TECHNICAL BULLETIN

MODIFICATION LANDING/HOVER LIGHT RELOCATION

Hover/Landing Light Installation, P/N 900E7750005-101.

Figure 1. Modification, Hover/Landing Light

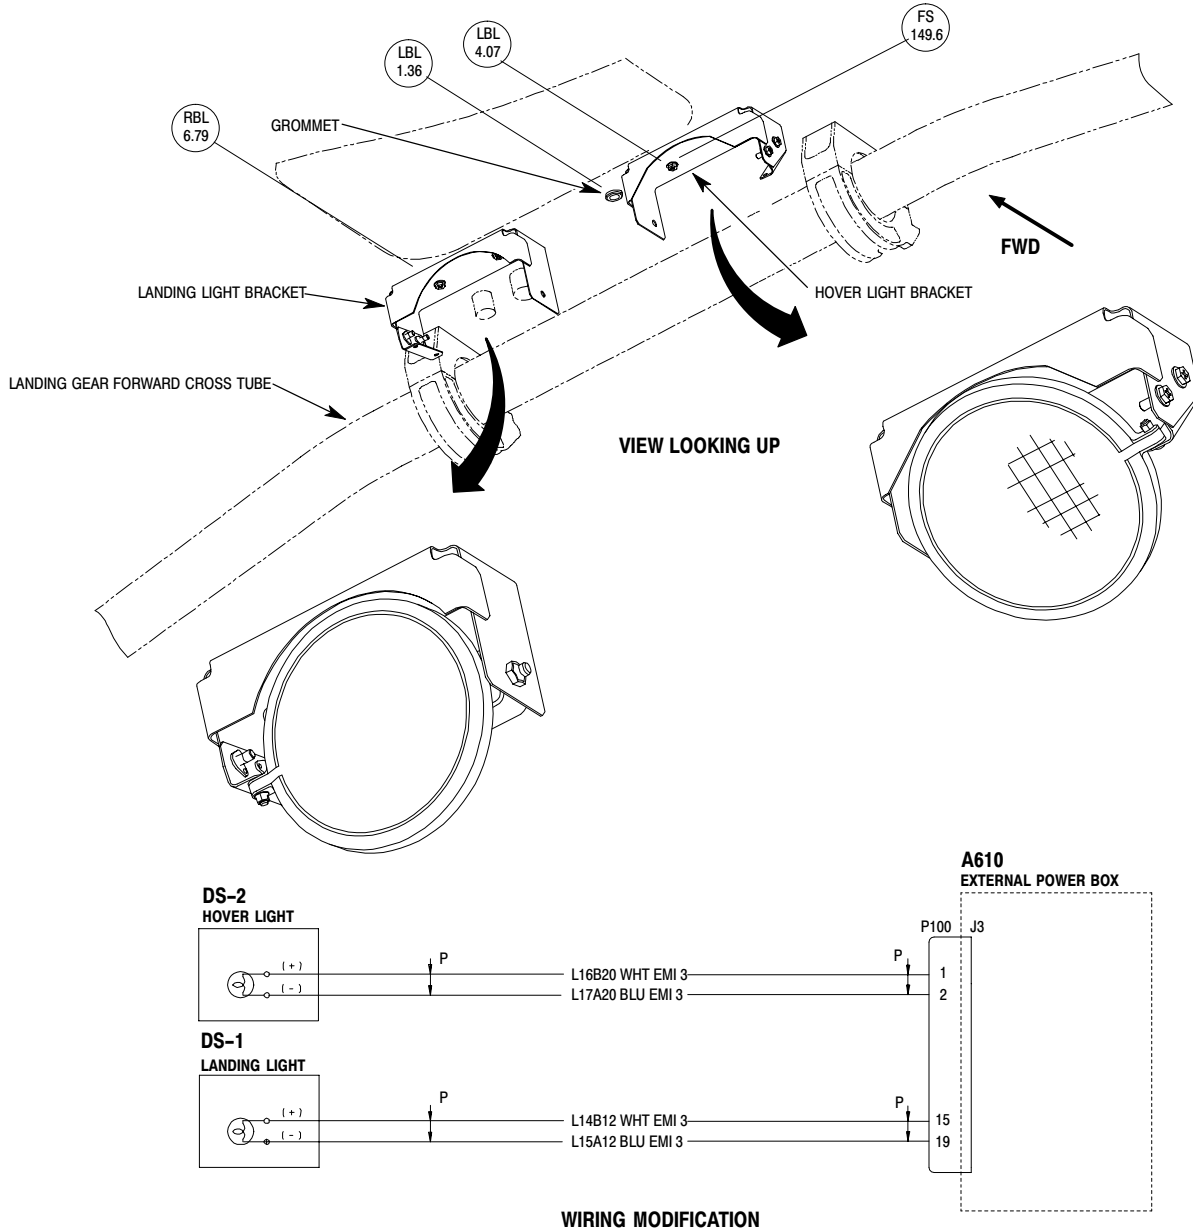
Procedures in this Bulletin provide owners and operators with information pertaining to modifying their rotorcraft for an updated landing/hover light installation. The 900E7750005 Hover/Landing Light Installation uses different mounting brackets than previous installations, to provide for greater mounting angle of the hover and landing light assemblies.

- (7). Environmentally seal grommet with MIL-S-8802 (Ref. CSP-SPM).
- (8). Apply polyethylene tape to 900E2750260 landing and 900E2750261 hover light bracket assemblies to fuselage faying surface.

- (9). Install landing and hover light bracket assemblies using 4 ea. NAS1096 screws and AN960JD washers. Install screws into existing nutplates and align bracket assemblies with butt line of aircraft. Torque screws (Ref. CSP-900RMM-2).

- (10). Attach two 900E2750262 adjustment bracket assemblies to the landing and hover light assemblies with 4 ea. NAS1096 screws and AN960JD washers. Do not torque hardware at this time.

- (15). Adjust landing light to 13° □ .5° in relation to aircraft waterline. Torque hardware (Ref. CSP-900RMM-2).
- (16). Adjust hover light to 36° □ 1° in relation to aircraft waterline. Torque hardware (Ref. CSP-900RMM-2).
